**THE CITY OF THE VILLAGE OF DOUGLAS
PLANNING COMMISSION
THURSDAY, AUGUST 13, 2026 AT 6:00 PM
415 WEST WILEY RD, SUITE 103, DOUGLAS, MI
49406**

To: City of the Village of Douglas Planning Commission
Date: August 3, 2026
From: Sean Homyen, Planning & Zoning Administrator
RE: 13 S Union St – Site Plan Amendment – Mix-Use Building

To: City of the Village of Douglas Planning Commission

RE: Douglas Mixed Use (225 Center Street) – Douglas
Engineering Review Comments

1. South Elevation

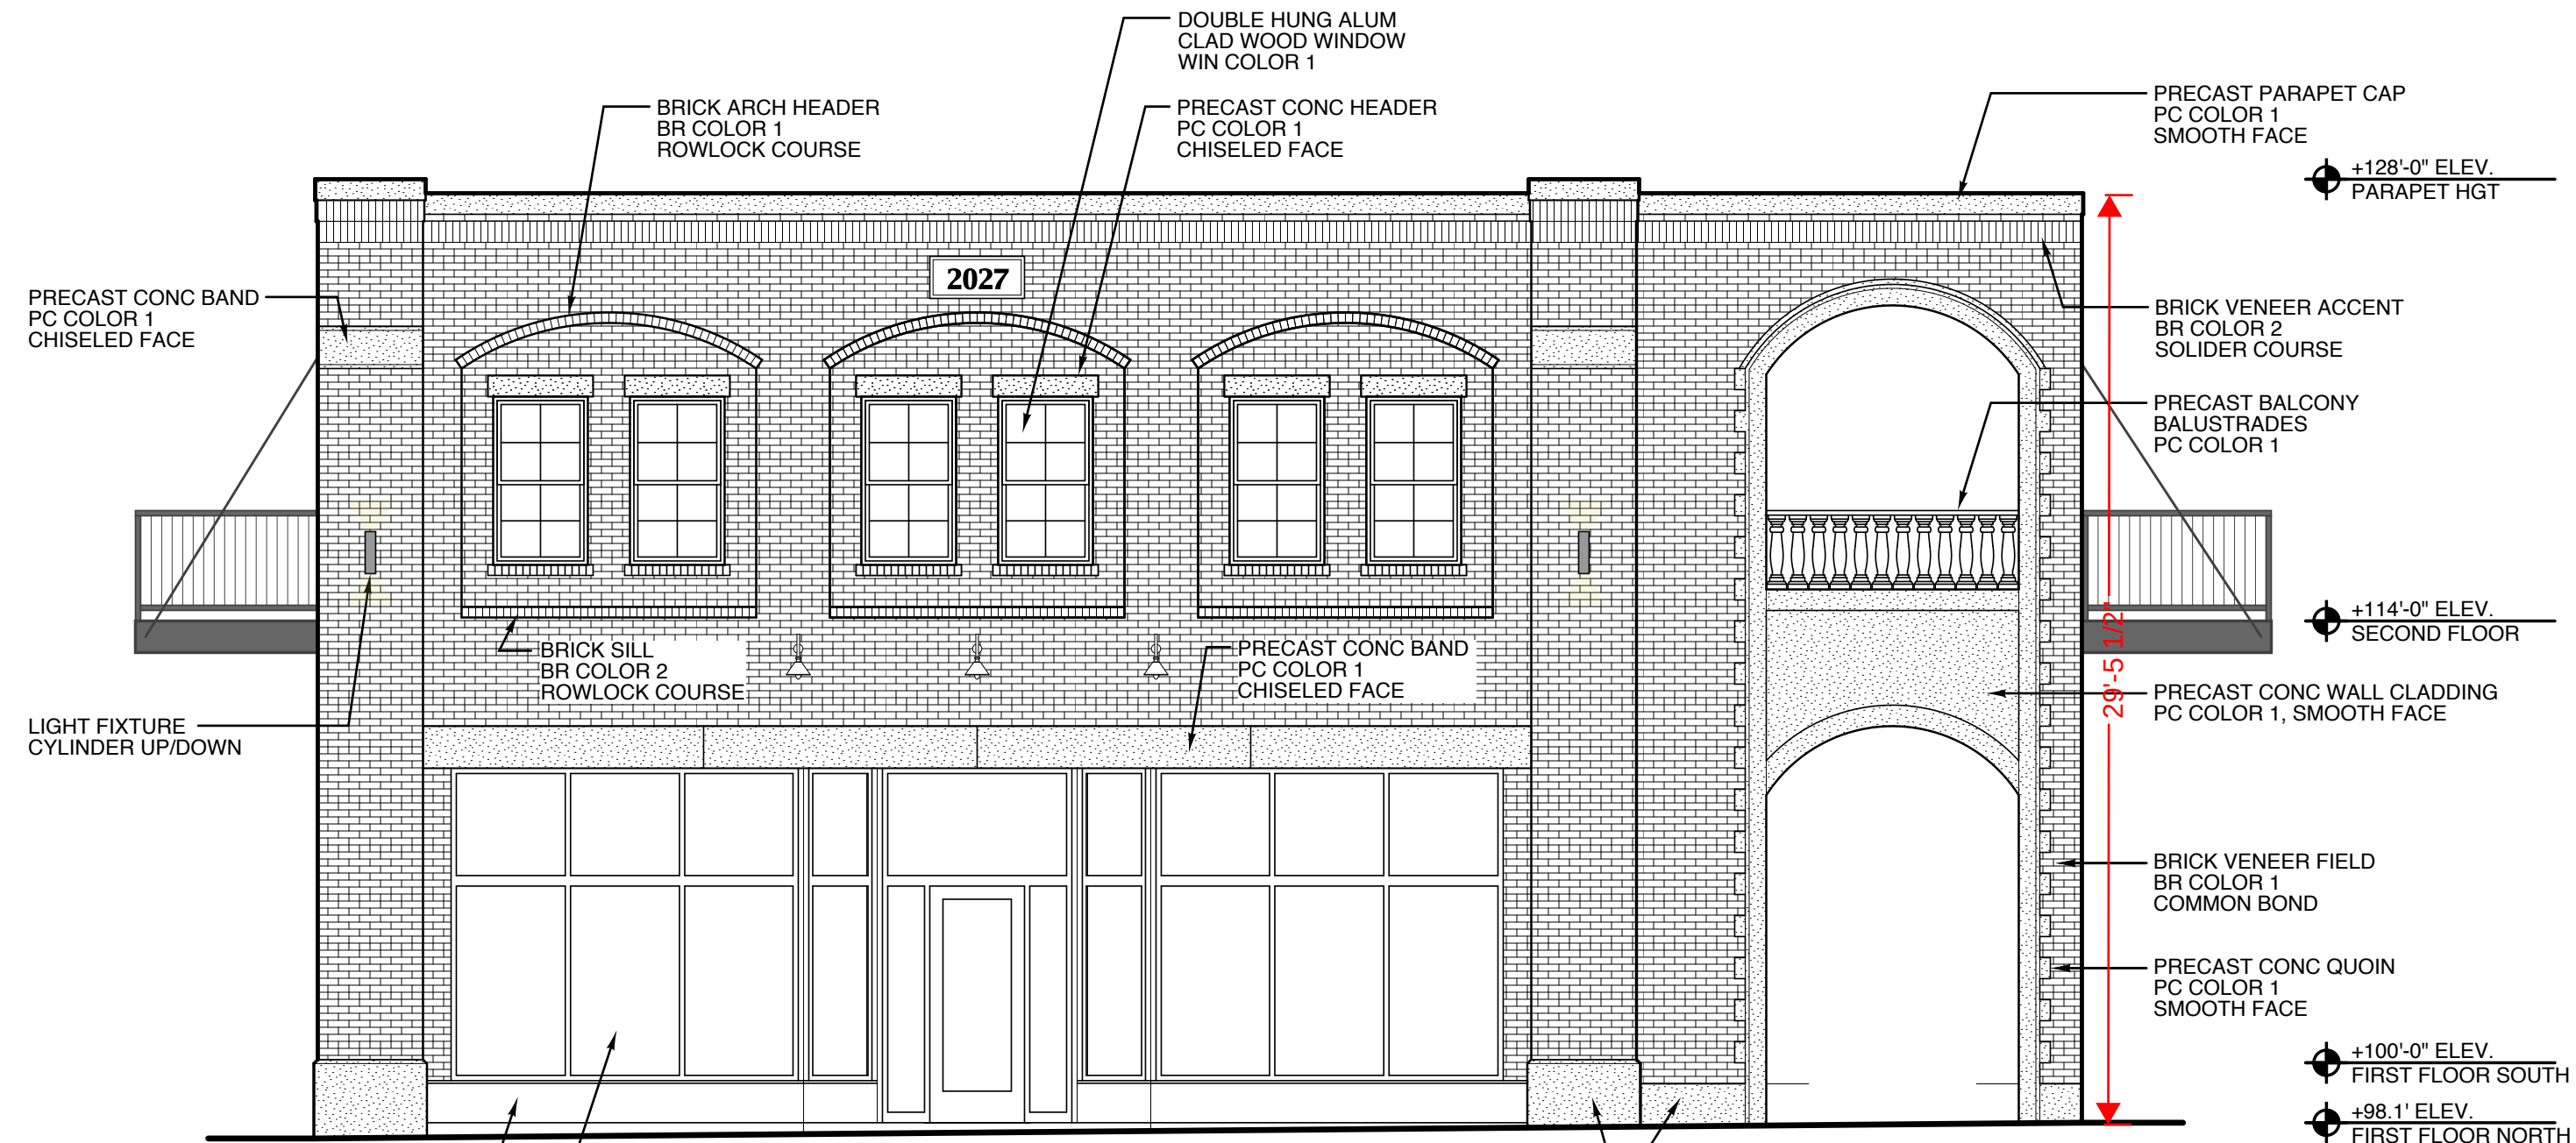
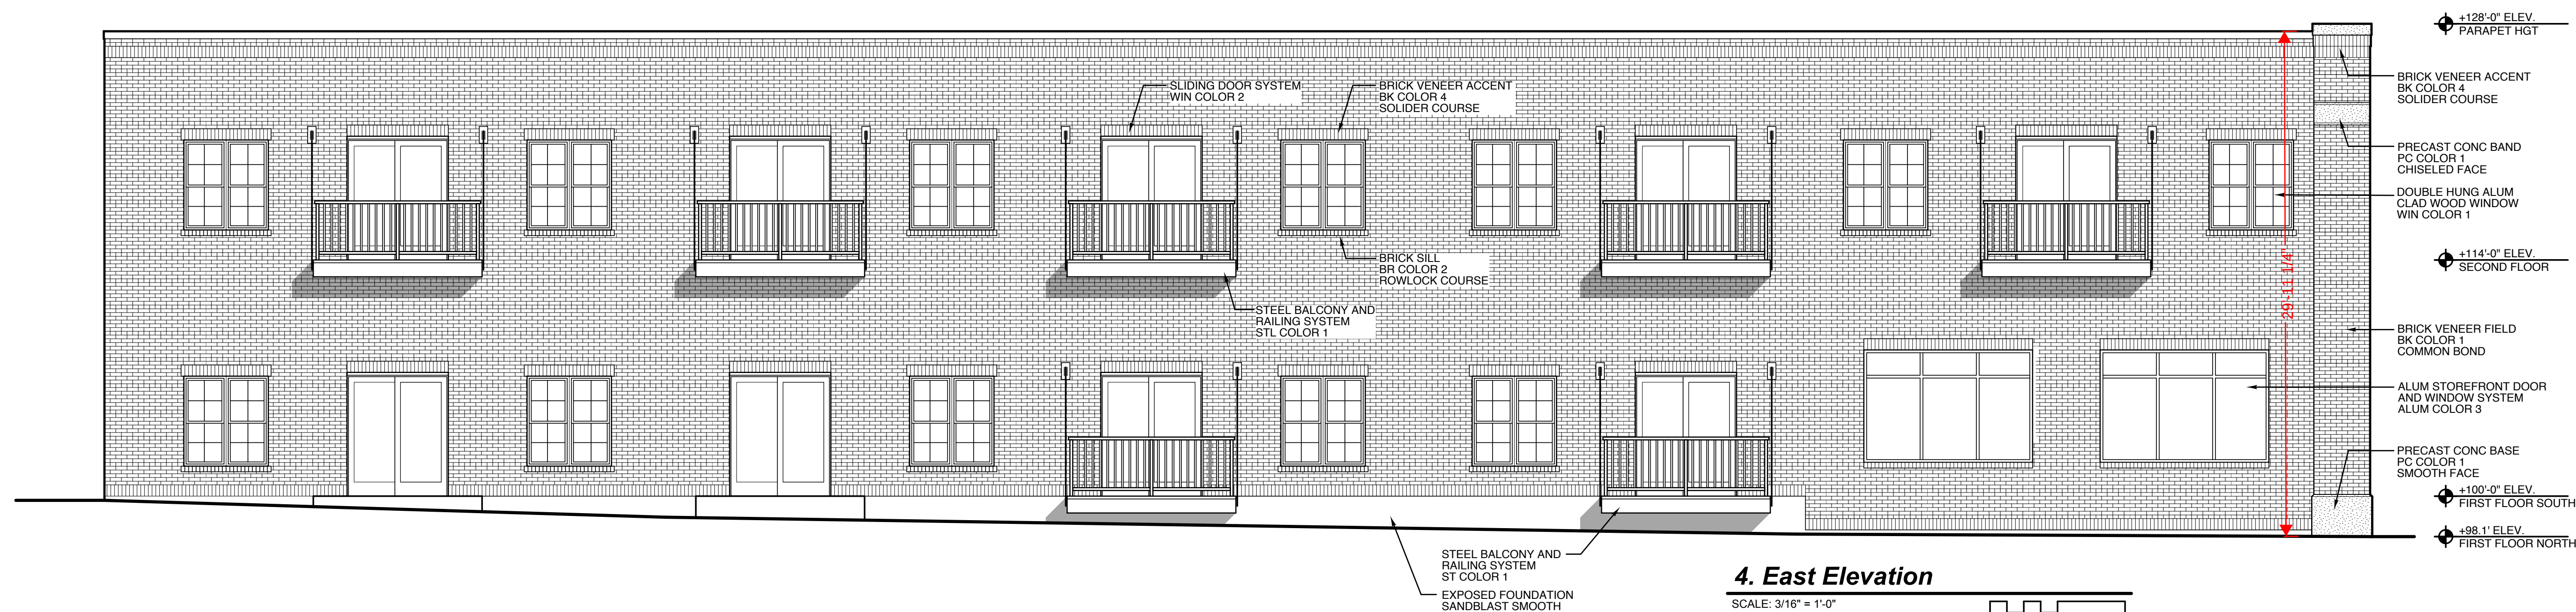
20. Where the vertical distance between the grade plane and the highest roof surface exceeds 30 feet (9144 mm), approved aerial fire apparatus access roads shall be provided. For purposes of this section, the highest roof surface shall be determined by measurement to the eave of a pitched roof, the intersection of the roof to the exterior wall, or the top of parapet walls, whichever is greater. (D105.1) **Approved, the top of the parapet wall is shown as 29' - 11 1/4" on plan A4.1.**
